Addendum #2

RE: Bock Park Phase One

This addendum forms part of the Contract Documents and modifies the original Bidding Documents as noted below. Acknowledge receipt of this addendum in the space provided on the Bid Form. Failure to do so may subject Bidder to disqualification. This addendum is (7) total pages and includes this (2) page memo, (5) revised drawing sheets which consist of the following changes.

1 SPORT COURT PAVING
 1" = 1'-0"

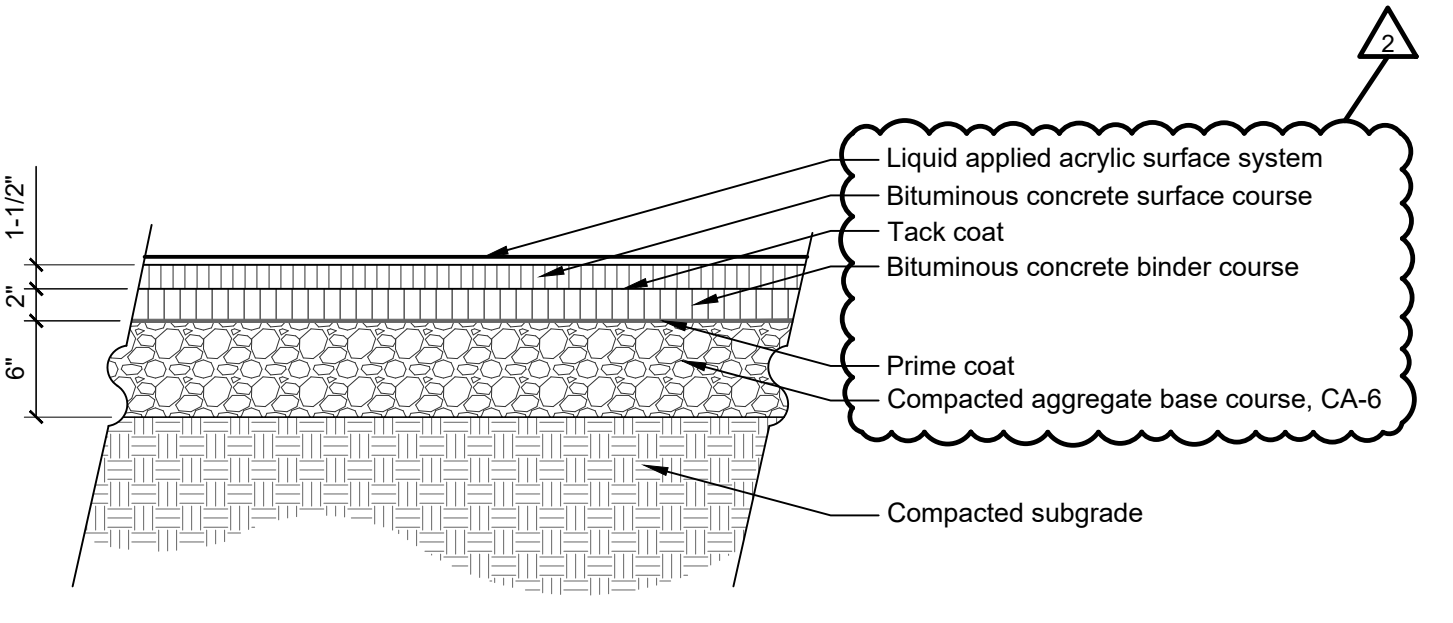
- Plexipave is an acceptable substitution for the sport court's color coat system.
- **Question:** L5.1 shows the detail for the Sport Court Paving. The detail calls for a "Pavement reinforcement system, see specifications" but there is no spec for this:

- Replace Sheet L5.1 Details:
 - “Pavement reinforcement system, see specifications” removed from Detail #1 – Sport Court Paving

- **Response:** *There will not be a pavement reinforcement system included in the sport court paving for this project. The note in that detail has been removed.*

**C1.1**

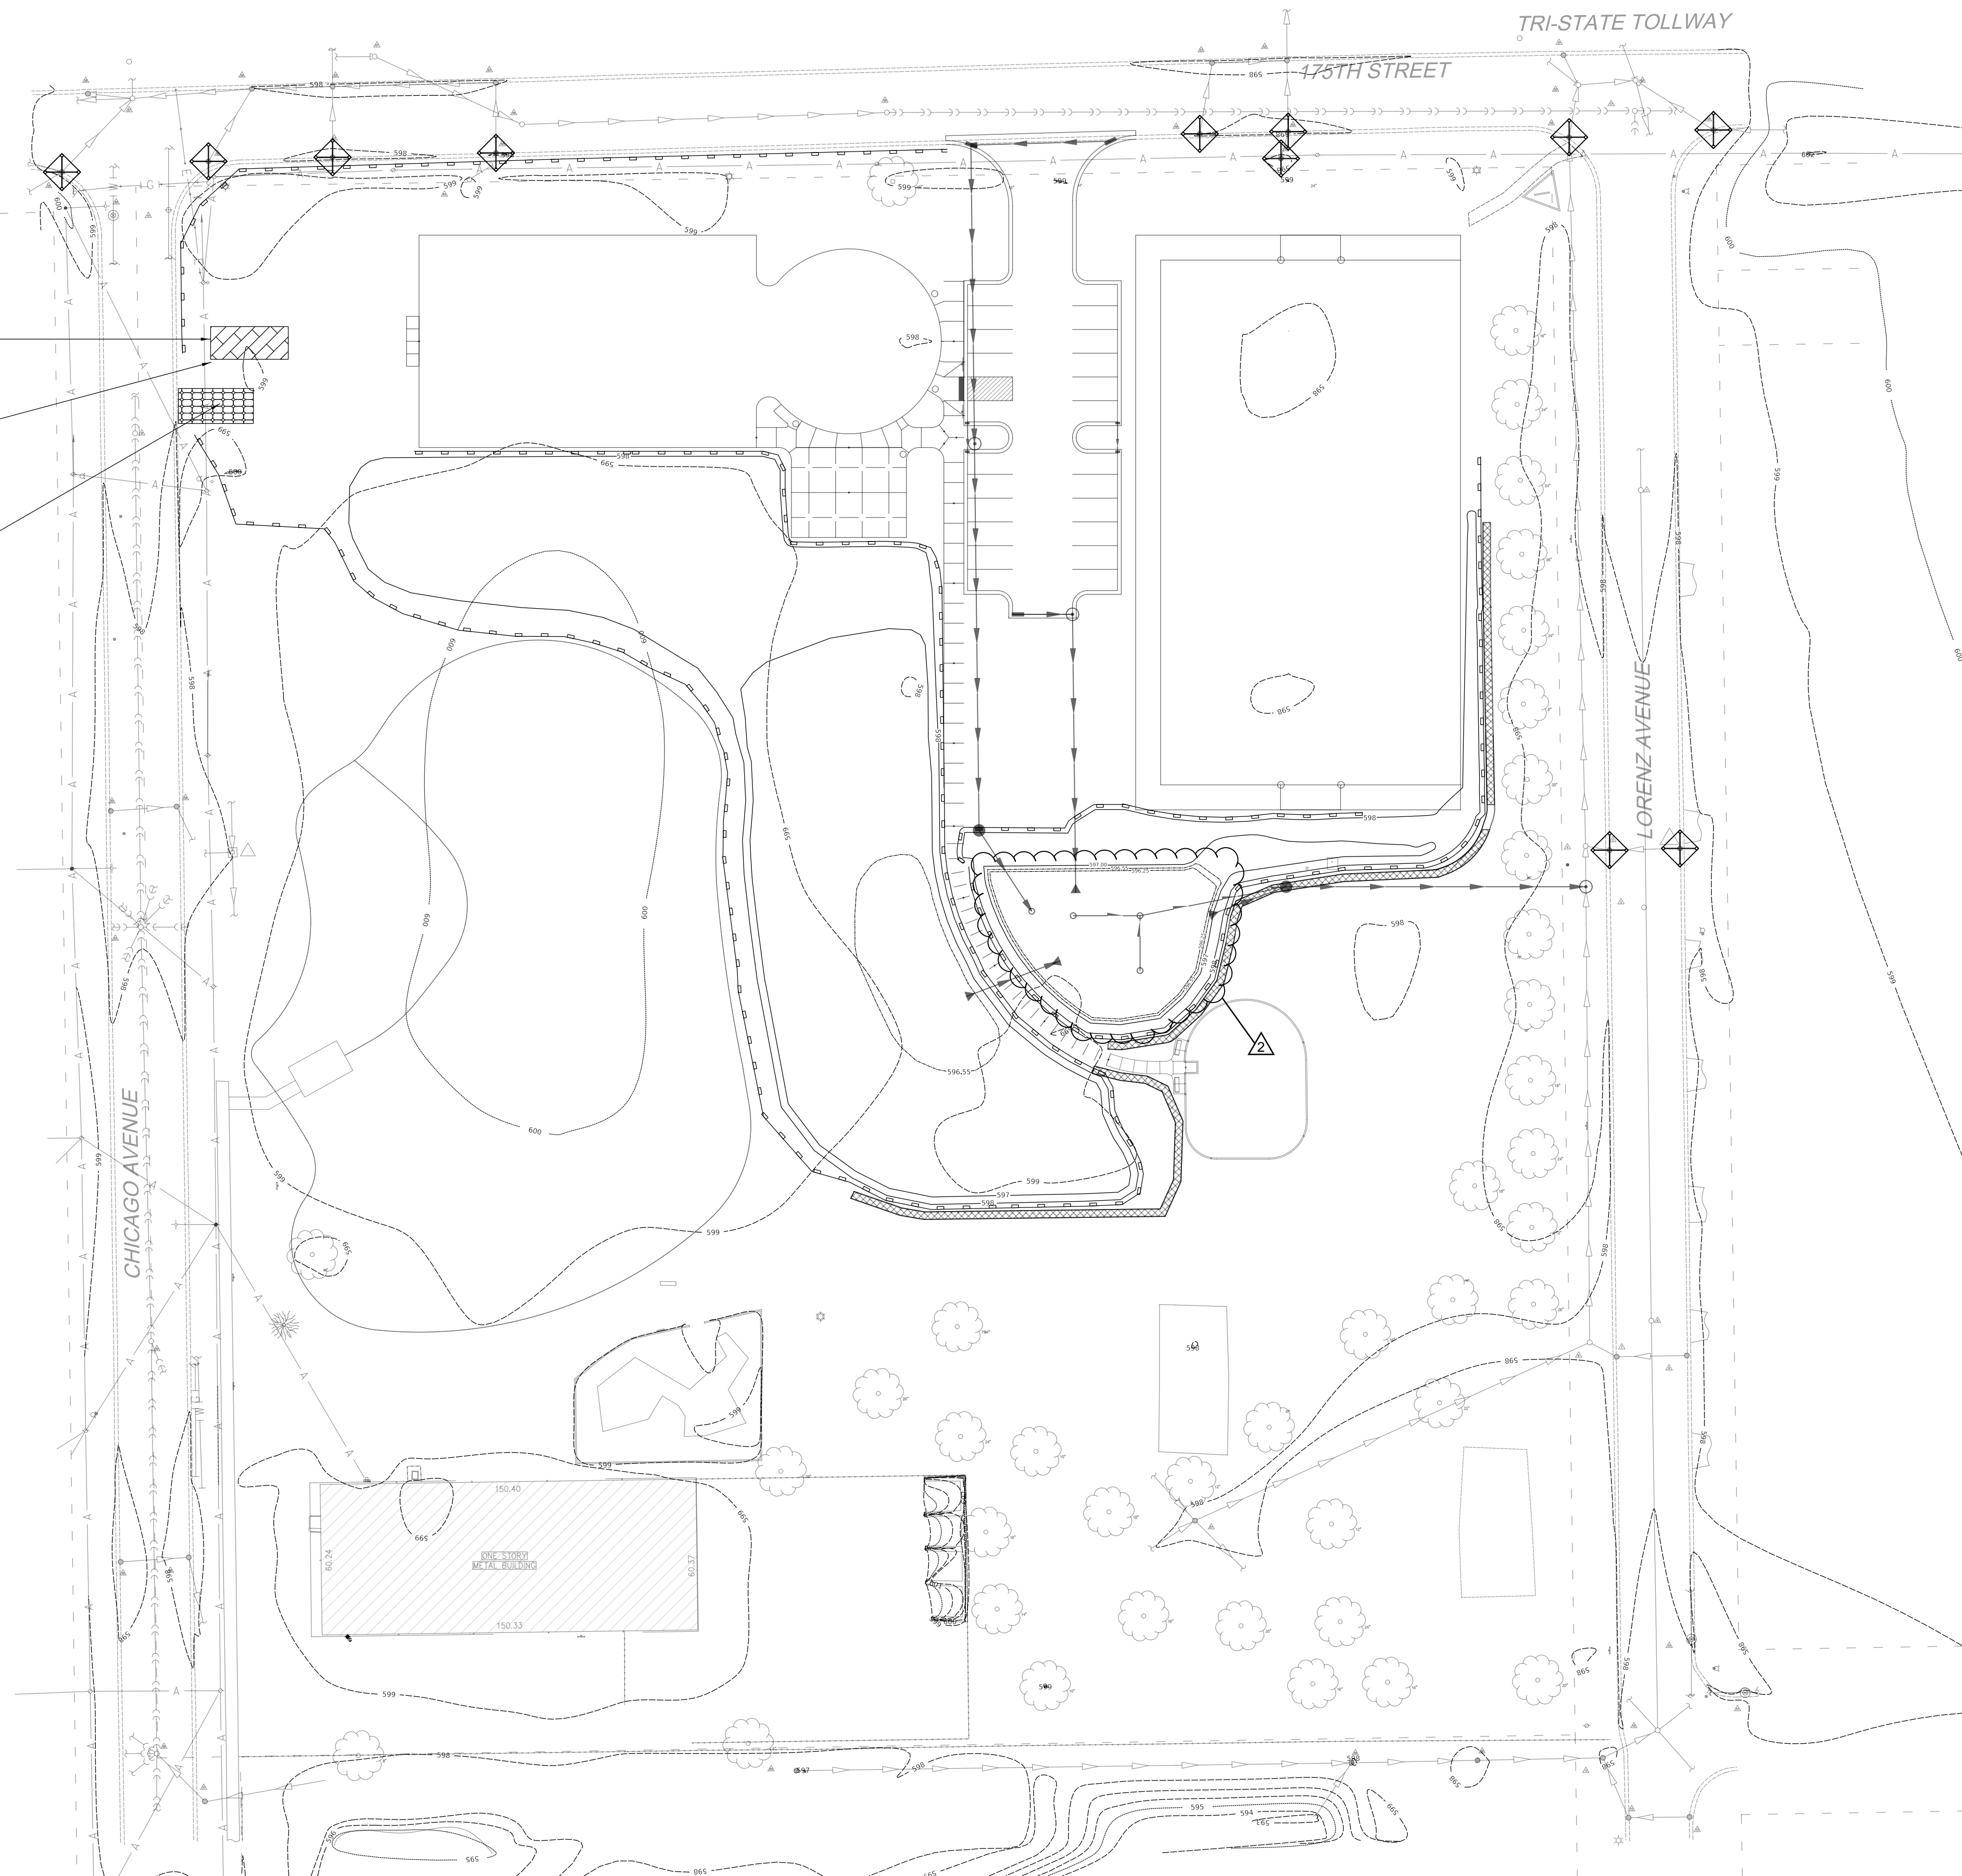
- **Question:** The elevations in the detail for the BMP do not match the civil plan for elevations. Civil shows bottom of pond at 593.30 but the BMP detail shows finish grade at 596.25 top of mulch. Detail shows bottom of aggregate at 593.30. Please advise:

- Replace Sheet C1.1 – Erosion/Sediment Control and Restoration Plan:
 - Providing updated contour information on plan and legend

- **Response:** *The BMP detail on sheet C4.2 reflects the correct subsurface and finished grade elevations. The proposed contours in sheets C1.1, C2.1, and C3.1 have been revised to only show the finished grade contours, consistent with the BMP detail. The following changes have been made in the plans:*

- *Sheets C1.1, C2.1, and C3.1: proposed contours in the east BMP cell have been revised to only include the finished grade contours.*
 - *Sheet C1.1 and C2.1: proposed and existing intermediate/index contour lines added to legend.*

SHEET NUMBER
C2.1
©2024 Hitchcock Design Group

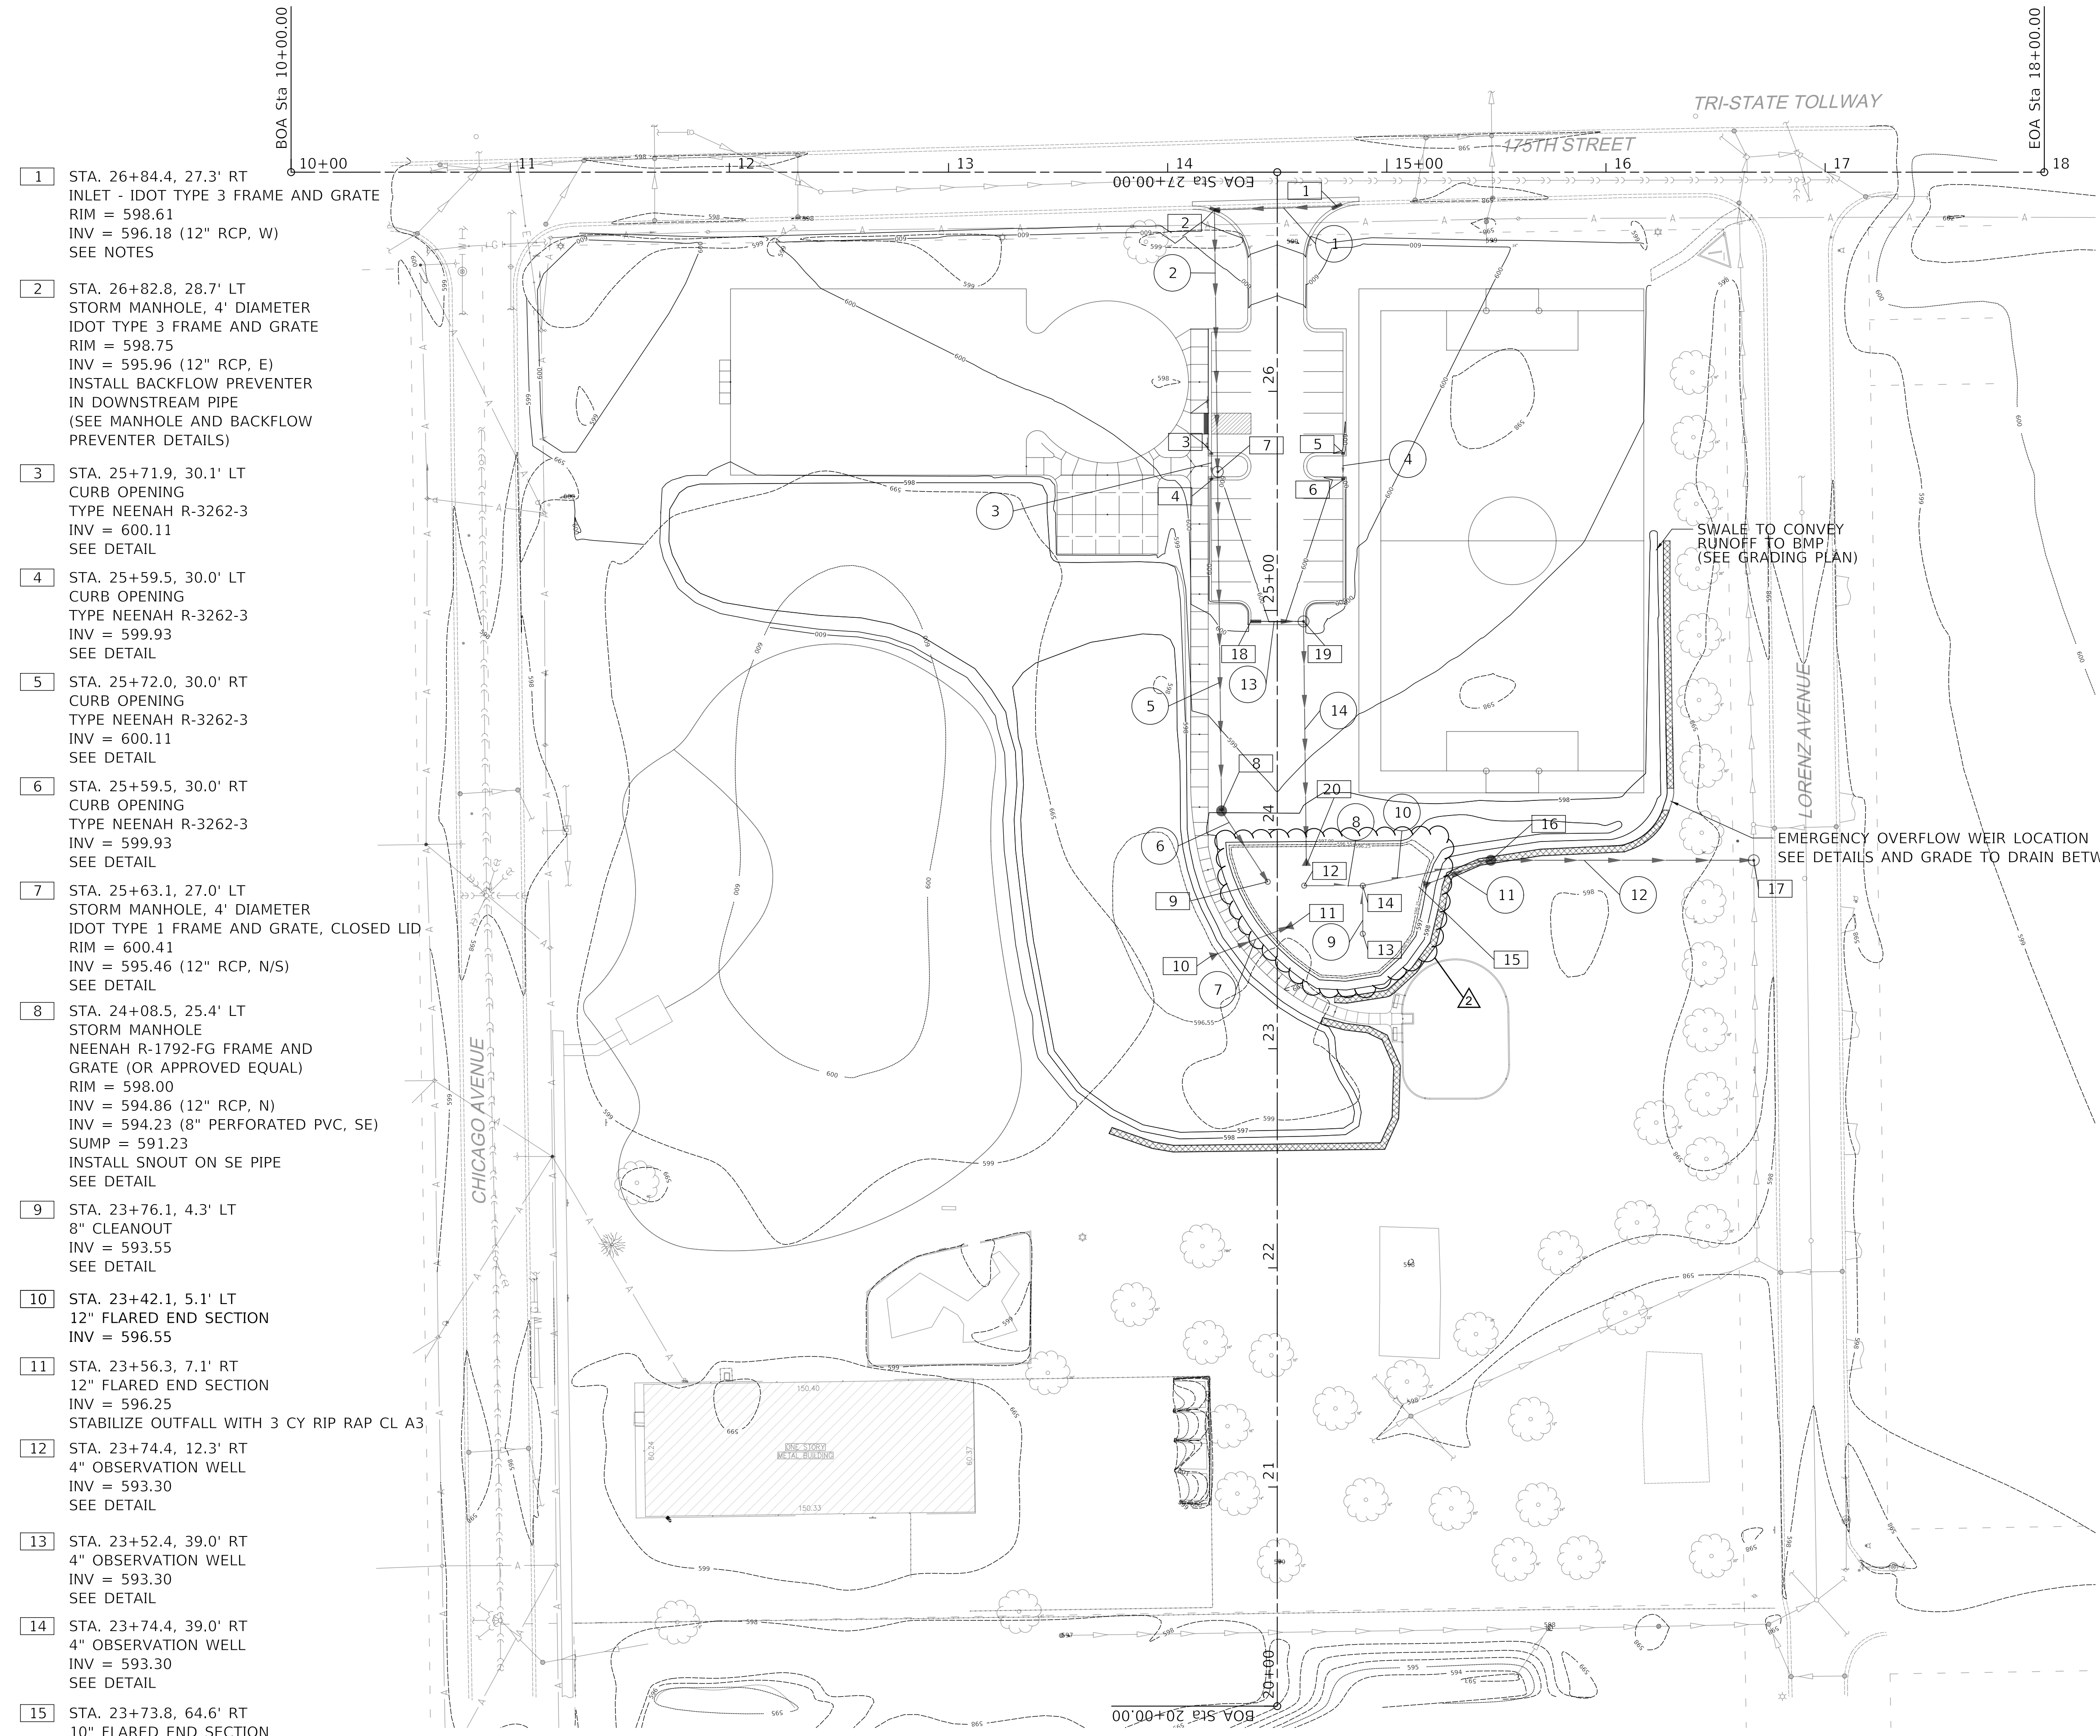
- *Sheet C4.2: arrow added to the detail to clarify the top of filter media elevation.*
- **Question:** The rim elevations of the catch basin and manhole at the south edge of the parking lot (18 & 19) are 599.86, while the southeast and southwest corners have an EP grade of 599.66. Confirm how water will flow from these corners to the south structures. It appears there is a low spot at the corners.

- Replace Sheet C2.1 – Drainage Plan:
 - Providing updated contour information on plan and legend

- **Response:** *On sheet C2.1, the rim elevations of drainage structures 18 and 19 have been lowered such that the south ends of the parking lot can drain to them. A note has also been added to indicate that the south gutters are to be graded towards these drainage structures.*
